NACELLE – POWERPLANT – TUBES, PRESSURE INDICATING – INSTALLATION OF A NEW IMPROVED ECS SENSE LINE TUBE

BULLETIN INDEX LOCATOR

V2500-ENG-36-0007

International Aero Engines SERVICE BULLETIN

REMOVAL/INSTALLATION OF THE ECS SENSE LINE TUBES Figure 1, Sheet 1 of 4

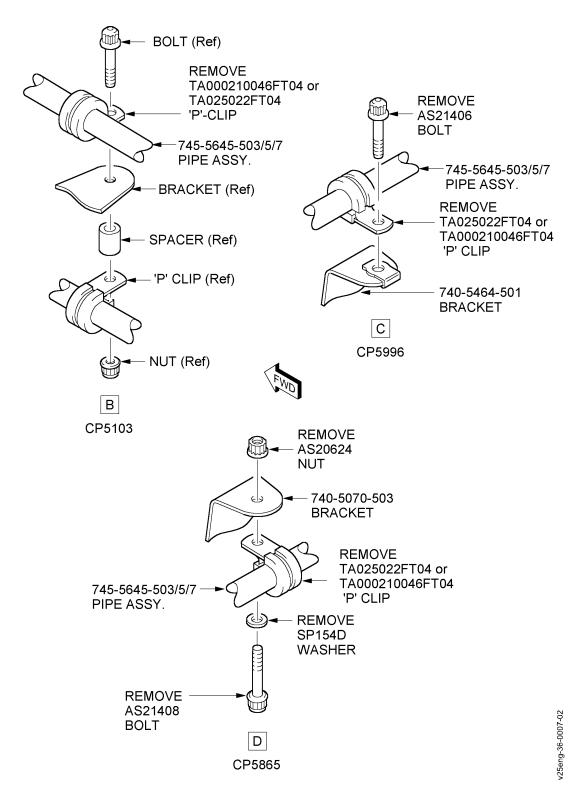
- (1) At Clipping Point 5103 (View on arrow B), remove the TA000210046FT04 or TA025022FT04 P-Clip around the Pipe 745-5645-503/5/7, Nut (Ref.), Bolt (Ref.) and Spacer (Ref.). (Refer to figure 1 shts 1 & 2 of 4).

- (4) At Clipping Point 5996 (View on arrow C), remove the AS21406 Bolt. Remove the TA000210046FT04 or TA025022FT04 P-Clip from around the Pipe 745-5645-503/5/7.

- (5) At Clipping Point 5865 (View on arrow D), remove the AS21408 Bolt, AS20624 Nut, and SP154D Washer. Remove the TA000210046FT04 or TA025022FT04 P-Clip from around the Pipe 745-5644-503/5/7.

- (6) At Clipping Point 5997 (View on arrow E), remove Nut (Ref.), Bolt (Ref.), and the TA000210046FT04 or TA025022FT04 P-Clip from around the Pipe 745-5644-503/5/7. (Refer to figure 1 shts 1 & 3 of 4).

- (12) Remove Pipe 745-5645-503/5/7.from the back of the P.R.V. Valve (View on arrow J) and Pipe 745-5644-503/5/7. (Refer to figure 1 shts 1 & 4 of 4).

- (15) Remove Pipe 740-5089-501/5/7 from between Pipe 745-5644-503/5/7 and the H.P. Valve.
- (16) Remove the Blanking Plug from the front of the PRV Valve (View on arrow K). (Refer to figure 1 shts 1 & 4 of 4). Install the Blanking Plug on the unused Sense Line Port at the rear of the PRV Valve. (View on arrow L). (Refer to figure 2 shts 1 & 3 of 3).

REMOVAL/INSTALLATION OF THE ECS SENSE LINE TUBES Figure 1, Sheet 2 of 4

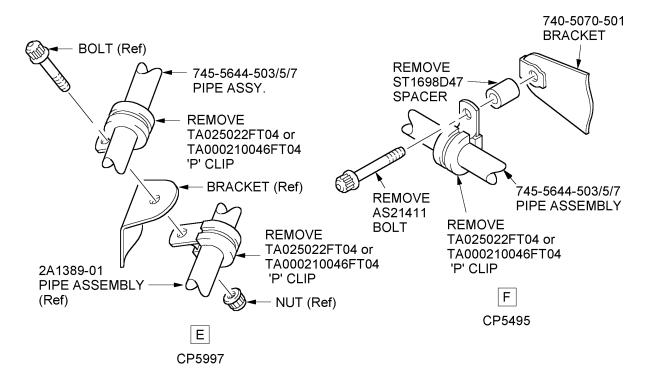
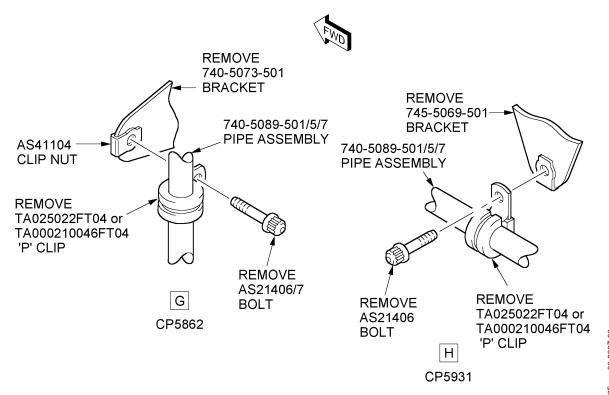
- (2) At Clipping Point 5103, re-assemble the Nut (Ref.), Bolt (Ref.) and Spacer (Ref.).
- (3) Torque tighten the Bolt (Ref.) to 20-25 lbf in (2.3-2.8 Nm).

REMOVAL/INSTALLATION OF THE ECS SENSE LINE TUBES Figure 1, Sheet 3 of 4

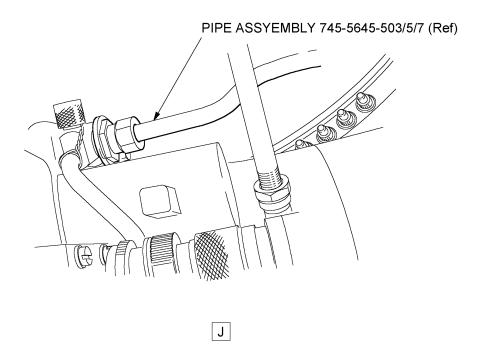
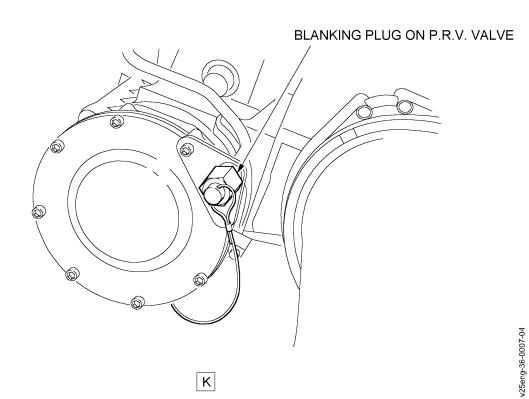
- (7) At Clipping Point 5997 (View on arrow E), re-assemble the Nut (Ref.), Bolt (Ref.) and Spacer (Ref.).
- (8) Torque tighten the Bolt (Ref.) to 20-25 lbf in (2.3-2.8 Nm).

REMOVAL/INSTALLATION OF THE ECS SENSE LINE TUBES Figure 2, Sheet 1 of 3

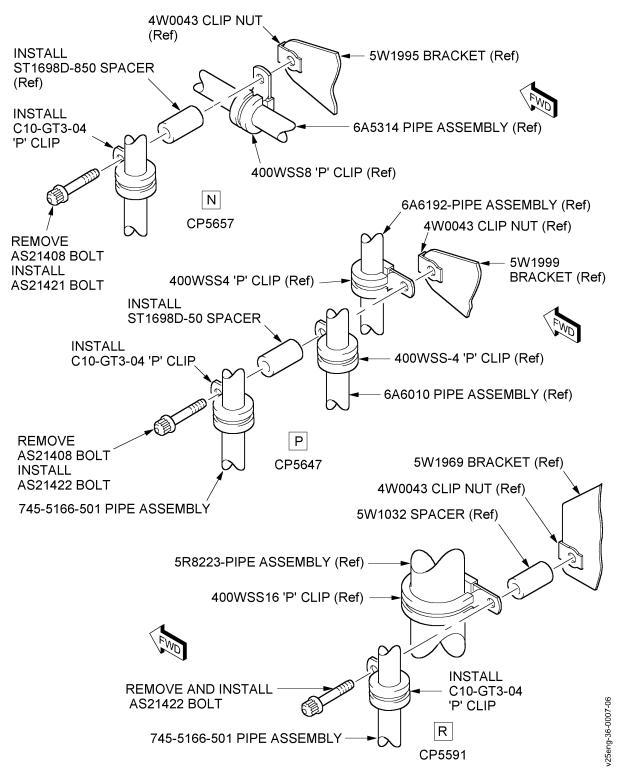
- (17) Torque tighten the Blanking Plug to 135 lbf in (16 Nm).
- (18) Install the 745-5166-501 Pipe onto the front of the PRV Valve. (View on arrow M). (Refer to figure 2 shts 1 & 3 of 3).

- (21) Install the (Ref. only-RR) 6J3084N Pipe onto the T-Piece of the 745-5166-501 Pipe. (Refer to figure 2 sht. 1 of 3).
- (22) Torque tighten the (Ref. only-RR) 6J3084N Pipe End Fitting to 240-290 lbf in (27.1-32.7 Nm).

- (23) At Clipping Point 5657 (View on arrow N), remove the AS21408 Bolt from the (RR) 5W1995 Bracket. Install the C10 GT3-04 P-Clip around the Pipe 745-5166-501. (Refer to figure 2 shts 1 & 2 of 3)

REMOVAL/INSTALLATION OF THE ECS SENSE LINE TUBES Figure 2, Sheet 2 of 3

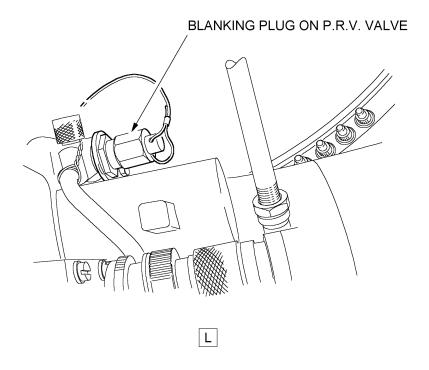
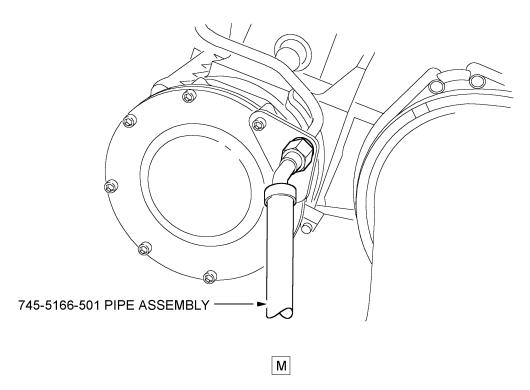
- (24) Assemble Clipping Point 5657. Install the AS21421 Bolt, C10 GT3-04 P-Clip, ST1698D-50 Spacer and 4W0043 Clip-Nut onto the (RR) 5W1996 Bracket.
- (25) Torque tighten the AS21421 Bolt to 20-25 lbf in (2.3-2.8 Nm).
